Staff Report for Administrative Approval Hillside Review – Notice of Conditional Approval

Weber County Planning Division

Application Request: Consideration and action on a request to approve a Hillside Review for the Mountainside and Parkside Subdivisions in The Bridges PRUD.

File Number: HSR 2016-04

FIGURE 19

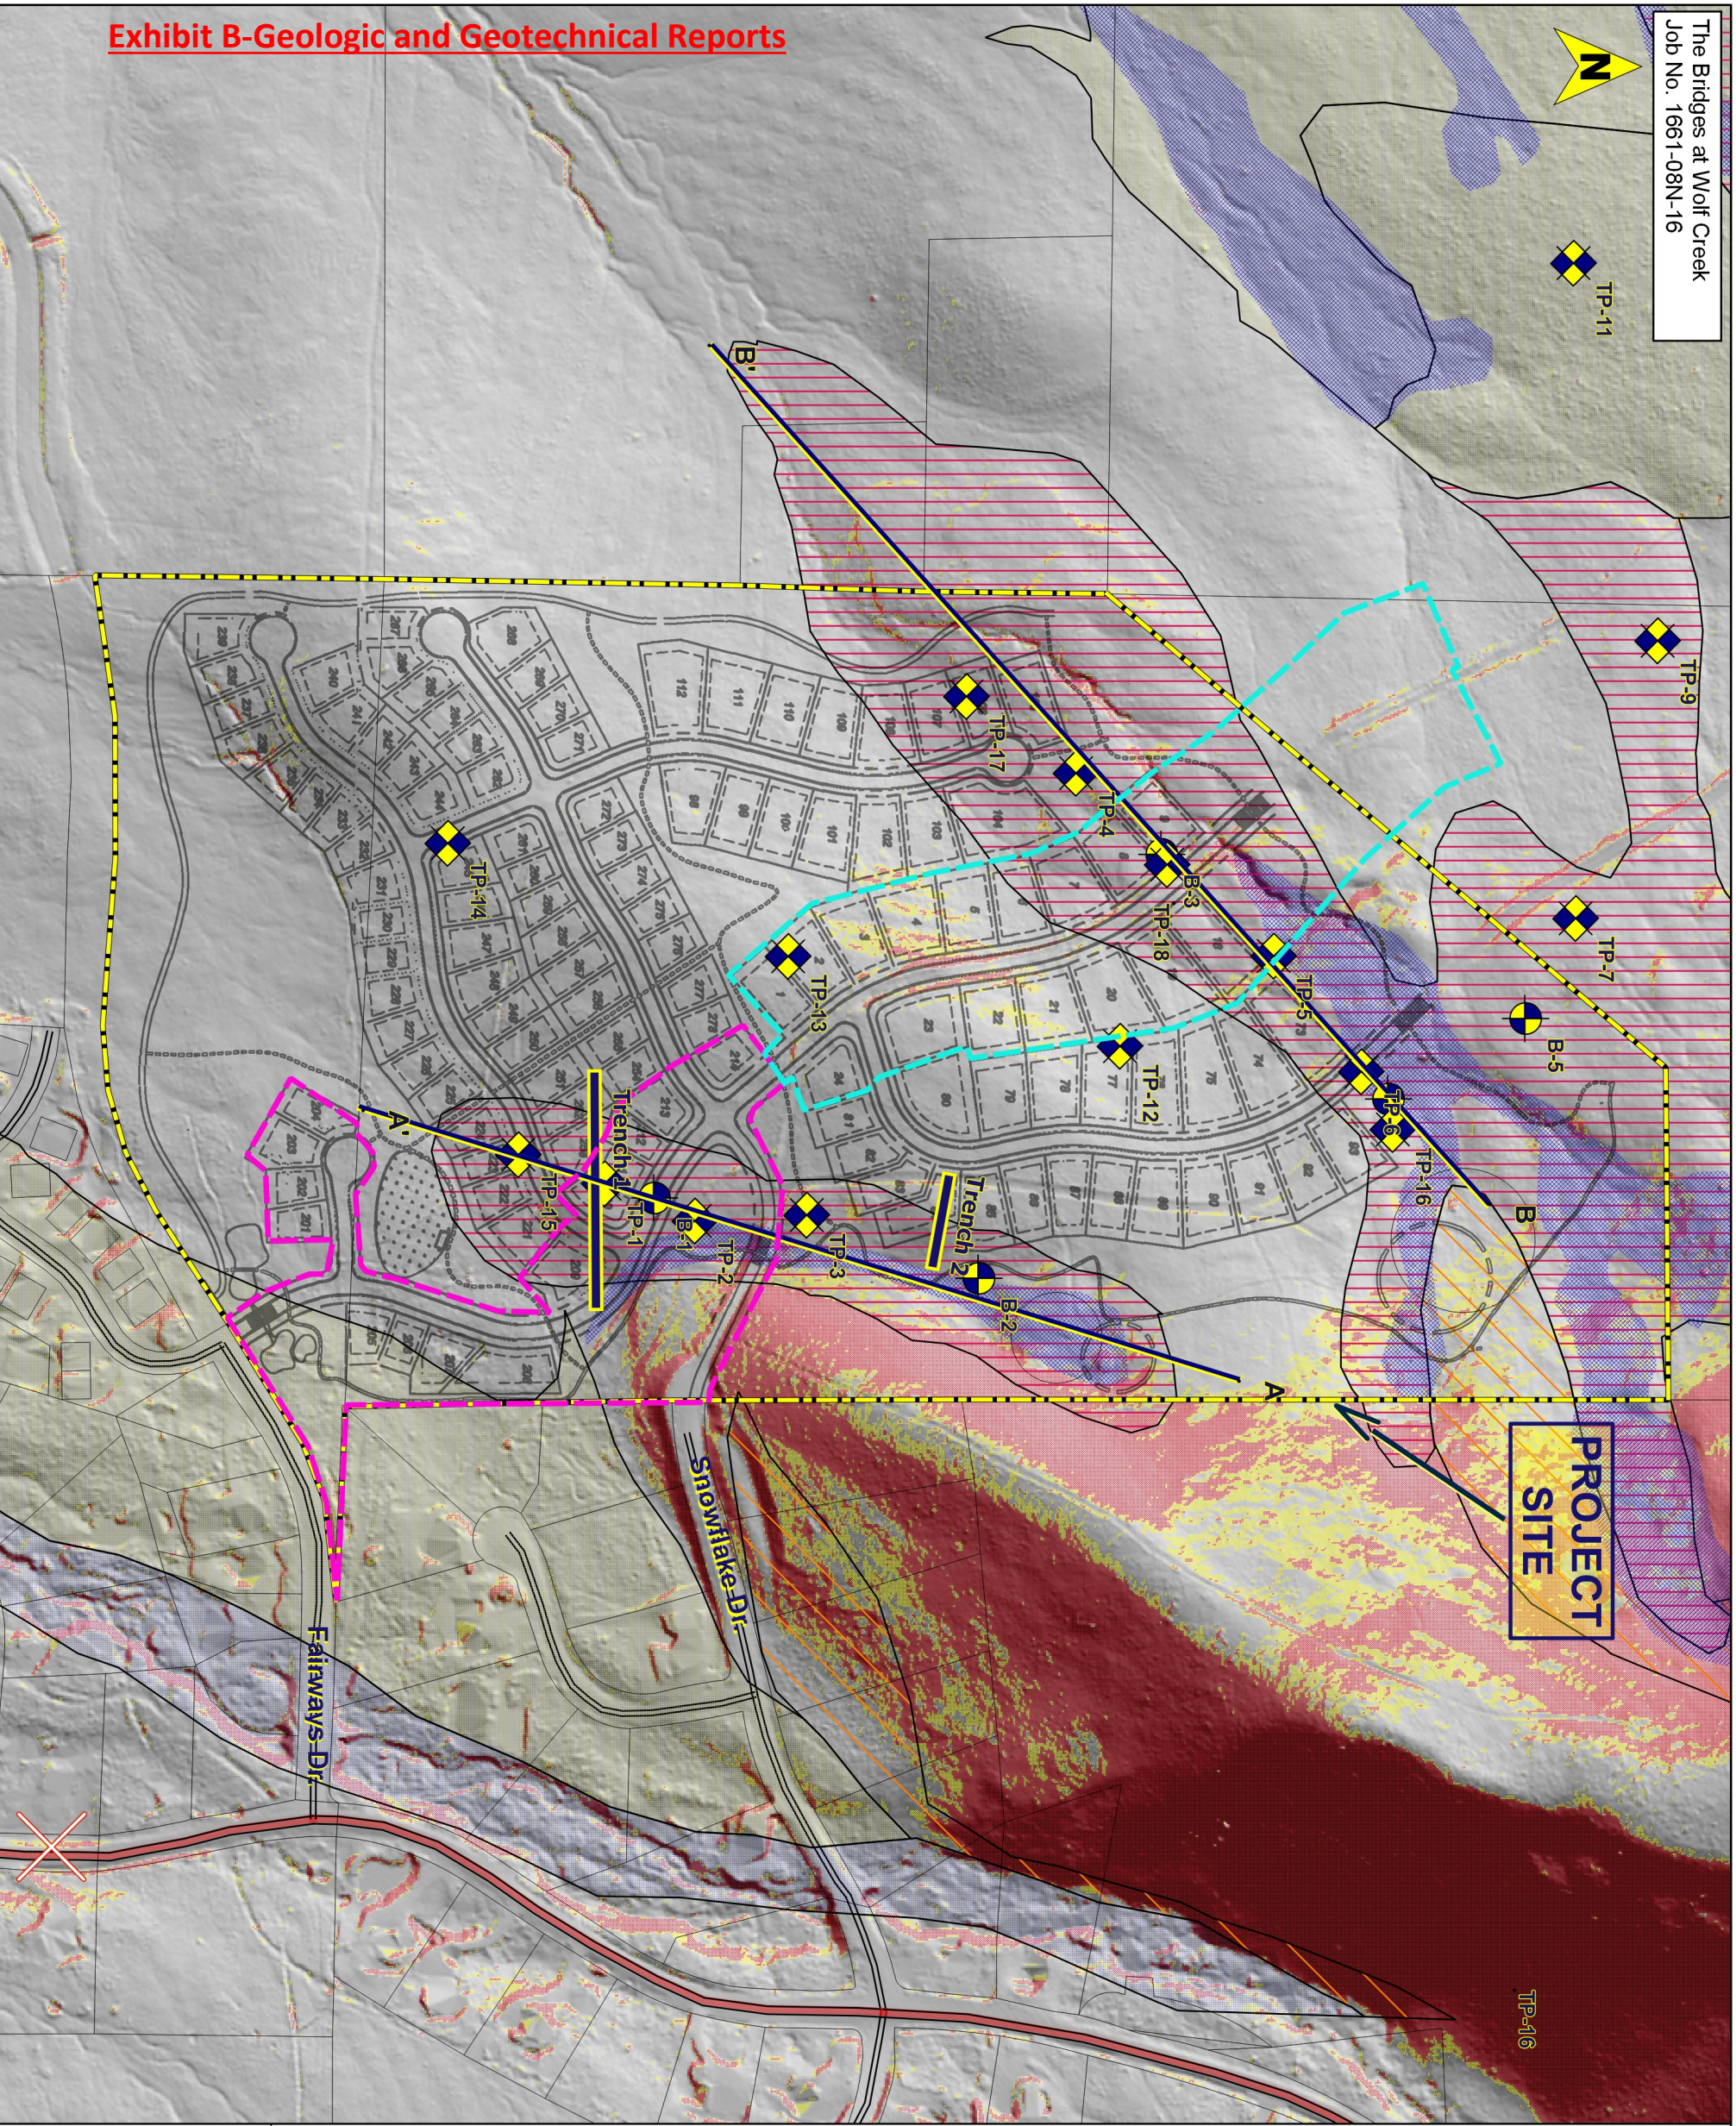
Inadvertently, the very western lots of the Mountainside Phase 1 (Lots 10 through 17) were not shown as part of the July 25, 2016 reporting, although these lots had been studied as part of the on-going Master Plan studies. While the subject lots are not delineated on our mapping figures included in the July 25 reporting, the area of the subject lots are a part of our on-going analysis and appear on the on the mapping figures summarizing our July 25, 2016 analyses. Attached is a revised Figure 19, Geologic/Natural Hazards Exposure.

Through our previous studies referenced below, the area of western lots on the Mountainside Phase 1 (Lot 10-17) are located almost entirely outside delineated hazard areas (Lot 10 is mapped partially within a landslide hazard area).

FIGURE 19

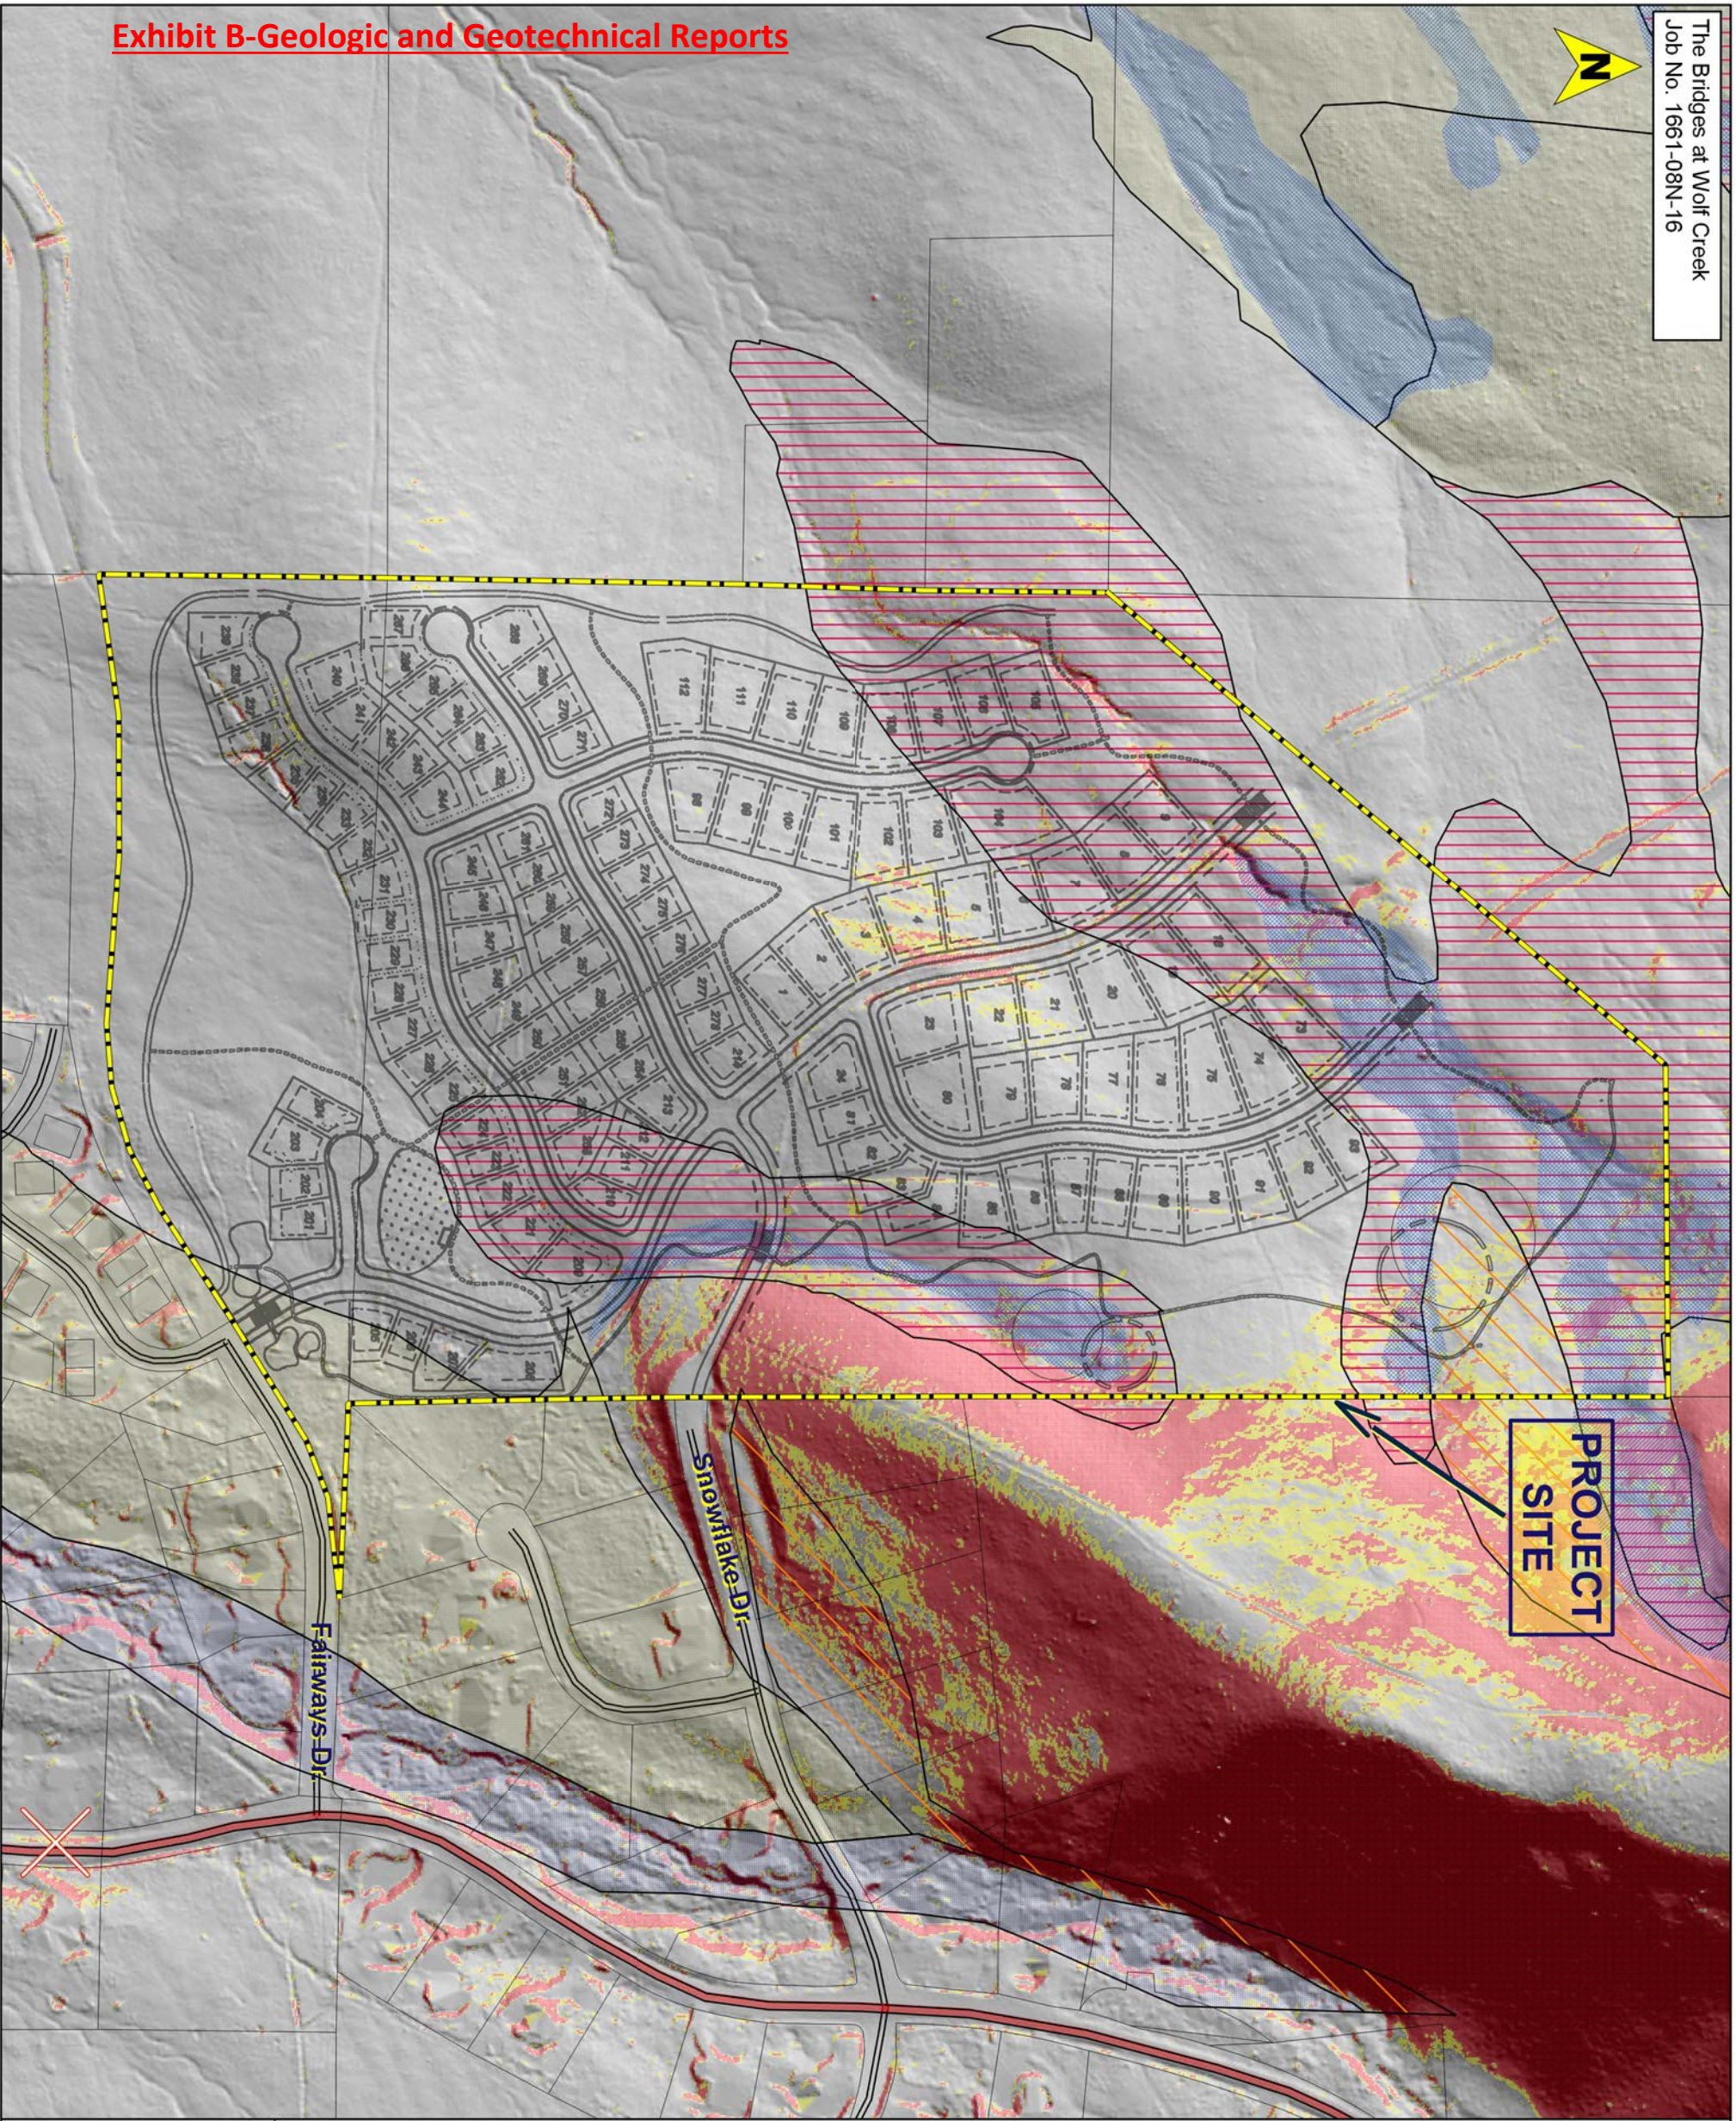
1. Each lot which has any designation of Landslide potential per Figure 19 will need to be addressed with an individual geologic study.
2. Future roadways be addressed per the geologic study or roadways be realigned to avoid the hazard as shown on Figure 19.
